# UNITED STATES PATENT AND TRADEMARK OFFICE

APPLICATION NO.	FILING DATE	FIRST NAMED INVENTOR	ATTORNEY DOCKET NO.	CONFIRMATION NO.
10/586,607	07/19/2006	Tetsuya Kohno	293159US3PCT	5945

<b>Office Action Summary</b>	<b>Application No.</b> 10/586,607	<b>Applicant(s)</b> KOHNO ET AL.	
	<b>Examiner</b> THOMAS DIAZ	<b>Art Unit</b> 3656

## **DETAILED ACTION**

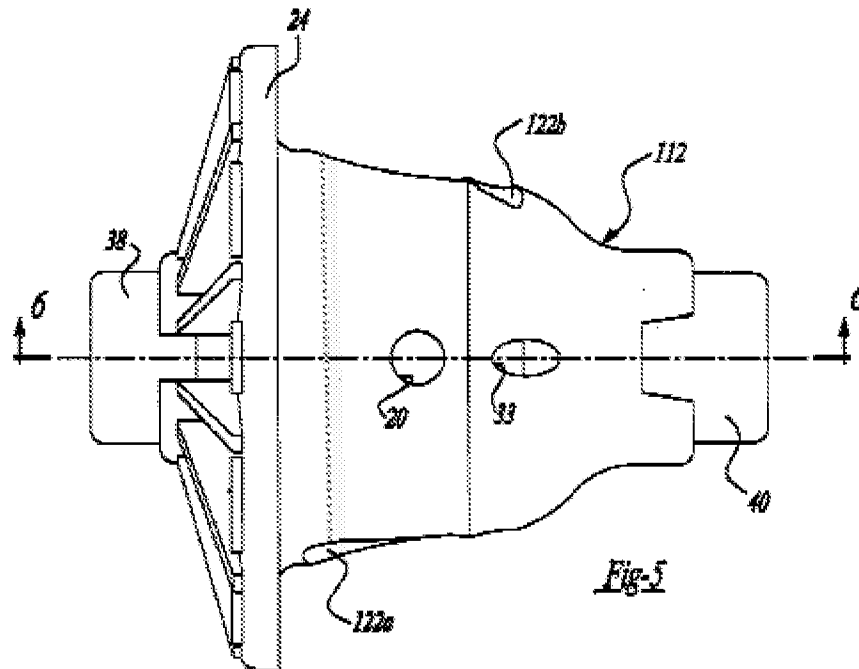
Regarding claim 23, Downs et al. discloses the claimed invention except for disclosing that the curvature radii of each of the corner portions are different. It would have been an obvious matter of design choice to use different radii of curvature for the different corner portions since applicant has not disclosed that ***each of the curvature radii of each of the corner portions are different*** solves any stated problem or is for any particular purpose and it appears that the invention would perform equally well with the shape disclosed by Downs et al. where the adjacent corner portions are of different radius of curvature.
